**Draft proposal for amendments to Regulation No. 43
(safety glazing)**

This document was prepared by the informal group on the introduction of plastic glazing for windscreens and laminated plastic panes other than windscreens in Regulation No. 43 (IGPG). It supersedes the informal document GRSG-103-20. The modifications to the current text of the Regulation are marked in bold or strikethrough characters.

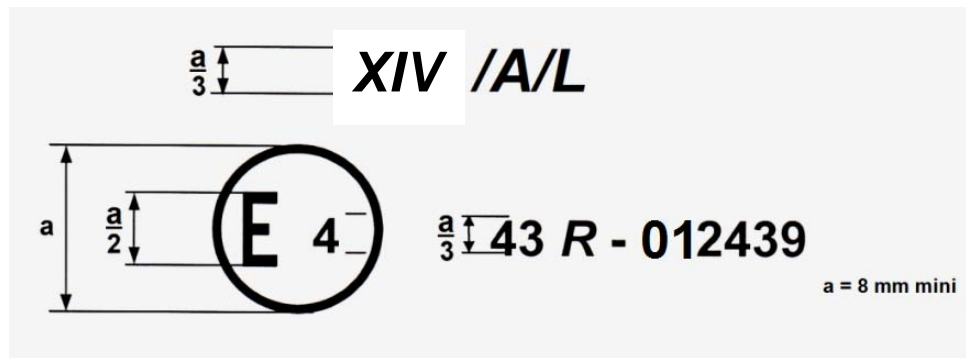
Annex 2, insert the following new paragraphs at the end of the Annex:

"Rigid plastic windscreens

The above approval mark affixed to a rigid plastic windscreen shows that the component concerned has been approved in the Netherlands (E 4) pursuant to Regulation No. 43 under approval No. 012439. The approval number indicates that the approval was granted in accordance with the requirements of Regulation No. 43, as amended by the 01 series of amendments.

Laminated rigid plastic panes

The above approval mark affixed to a laminated rigid plastic glazing pane for forward facing panels with a light scatter not exceeding 2 per cent after 1000 cycles on the outer surface and 4 per cent after 100 cycles on the inner surface shows that the component concerned has been approved in the Netherlands (E 4) pursuant to Regulation No. 43 under approval No. 012439. The approval number indicates that the approval was granted in accordance with the requirements of Regulation No. 43, as amended by the 01 series of amendments."

Figure XX sand drop equipment

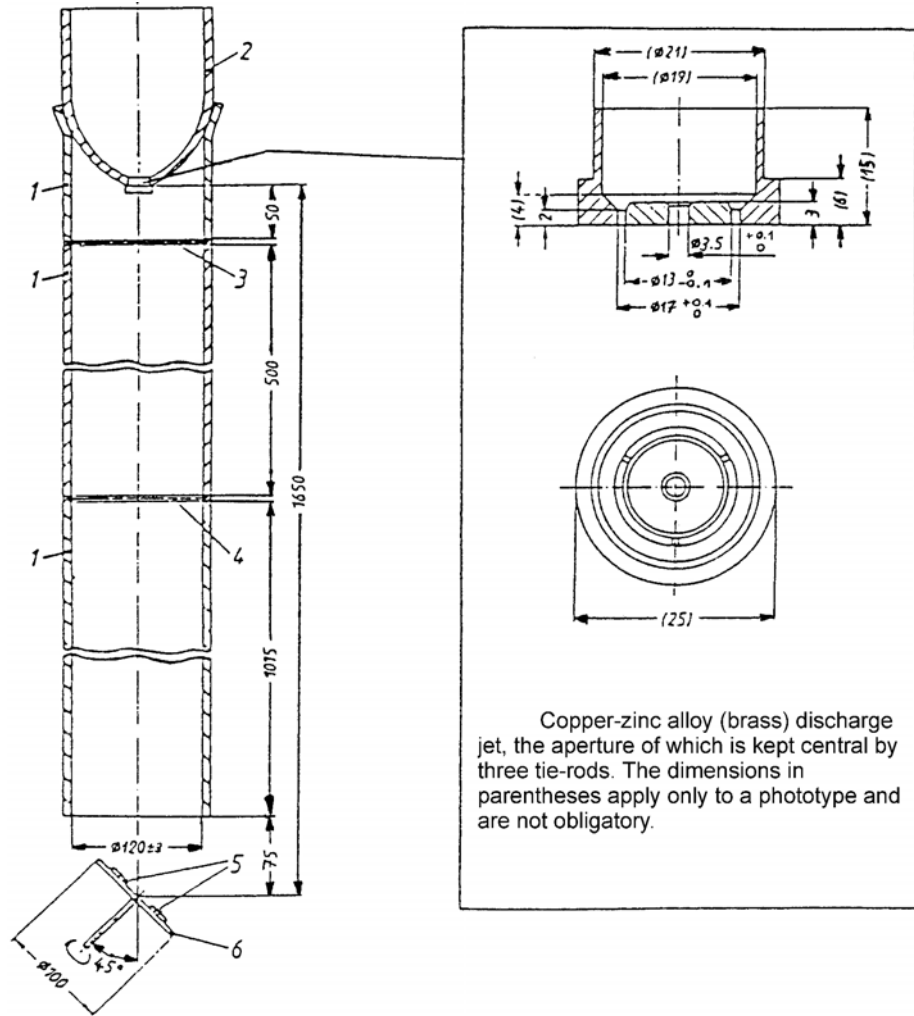
“4.7. Sand Drop Test

4.7.1. Apparatus

The sand drop test equipment consists essentially of that illustrated in Figure XX. The gravity tube consists of three separate rigid polyvinylchloride tubes (PVC hard) of the same diameter, with two polyamide sieves mounted in between. The sieves should have a mesh size of 1.6 mm. The speed of the turntable shall be 250 ± 10 rpm.

Figure XXX - Movement pattern of washing brush and nozzle

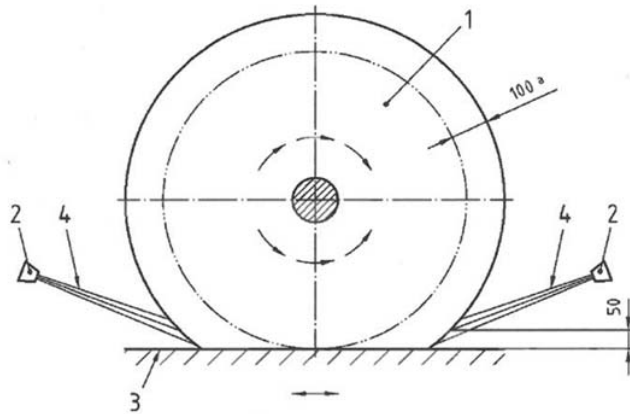
4.8.1. Apparatus

diameter	(1 000 ± 40) mm
width	Minimum 300 mm
rotation speed	(127 ± 5) min ⁻¹
brush rotation	rotates in the opposite direction relative to the direction of travel of the test panel holder
material	polyethylene
bristle profile	x-shaped, spliced
bristle thickness	(0.8 ± 0.2) mm
bristle length	(440 ± 20) mm visible
penetration depth	(100 ± 20) mm (see figure XXX)

number	2 (spray alternatively and against the direction of travel of the test panel holder)
material	stainless steel
spread of jet	65°
water flow rate	(2.2 ± 0.1) l/min at (300 ± 50) kPa

The two nozzles shall spray alternately and against the direction of travel of the test panel holder. They shall produce the specified spray pattern (see instrument calibration XXX1).

feed speed	(5 ± 0.2) m/min
pattern of movement	if the brush is rotating clockwise, the right nozzle is spraying and the test panel holder travels from the left side to the right side (and vice versa)

Figure XXX1 – calibration arrangement

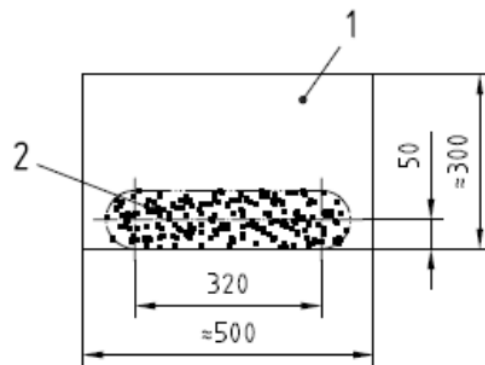
4.8.4.1.3. Do the instrument calibration as follows: Set up the equipment as shown in Figure XXX1. Fill with washing suspension (see paragraph 4.8.2. of this annex and wet the brush sufficiently. Determine the flow rate of the water, (2.2 ± 0.1) l/min, by measurement and adjust by altering the pressure, (300 ± 50) kPa. Check the spray pattern of the nozzles (see Figure XXX2) If the spray pattern cannot be achieved or if the pressure regulation exceeds the tolerances, check, and if necessary replace, the nozzles.
